Subject: LOW OIL LEVEL WARNING LIGHT COMES ON WHEN LEVEL IS NOT LOW	Bulletin No: 01-013/04
	Last Issued: 4/14/2004

This bulletin replaces 01-027/03 issued 11-17-2003. The PART(S) INFORMATION and WARRANTY INFORMATION have been revised.

2004 RX8 - VINS: JM1FE17* *40000000 to 40111043

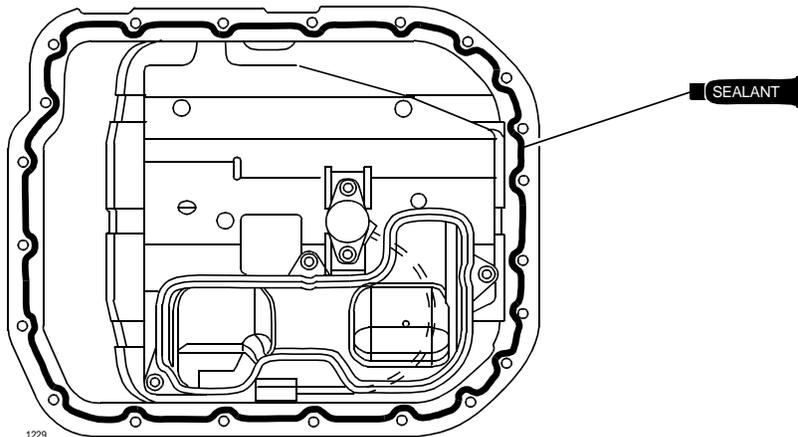
1. Remove the oil pan.
 - a. Disconnect the oil level sensor electrical connector from the side of the oil pan.
 - b. Remove the oil pan bolts (22-10mm)
 - c. Separate the oil pan from the engine
2. Install the new oil pan and level sensors assembly.
 - a. Clean all silicone sealant, oil and dirt from the engine.
 - b. Clean all silicone sealant from the oil pan bolts.
 - c. Apply a **2.5 to 6.5mm (0.10 to 0.26in)** bead of silicone sealant to the oil pan as shown.
 - d. Install the oil pan bolts and torque to **8.8 to 11.8Nm (77.9 to 104.4 inlb)**.
